Figure 178B-9 optimization

Jeff Slavick - Broadcom

Figure 178B-9—RTS update state diagram

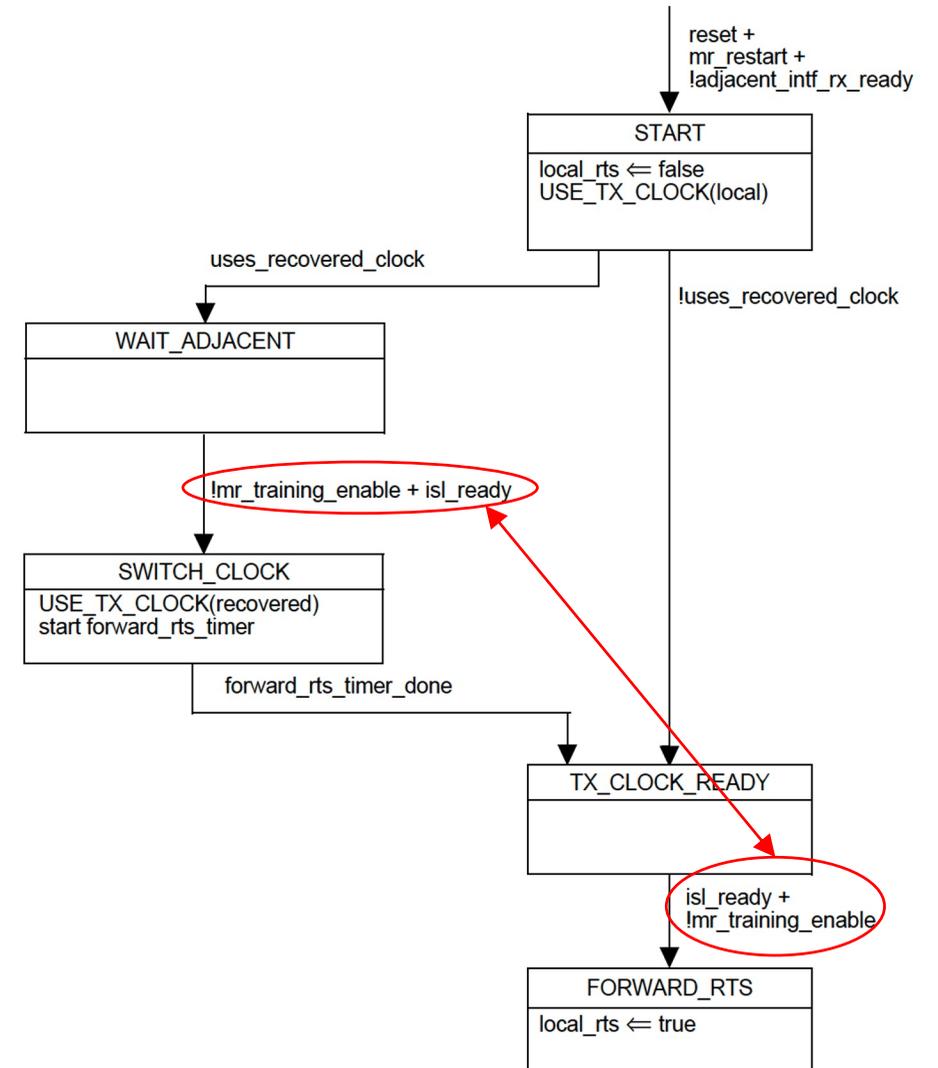
Figure 178B-9 could use a little optimization in structure

The two highlighted conditions are the same.

After SWITCH_CLOCK the condition will still be true, it won't be modified by the clock swap.

Updated diagram

Shift the check on whether `uses_recovered_clock` to be after the `isl_ready + !mr_training_enable` then we reduce the number of states and simplify the diagram and make its flow more intuitive.
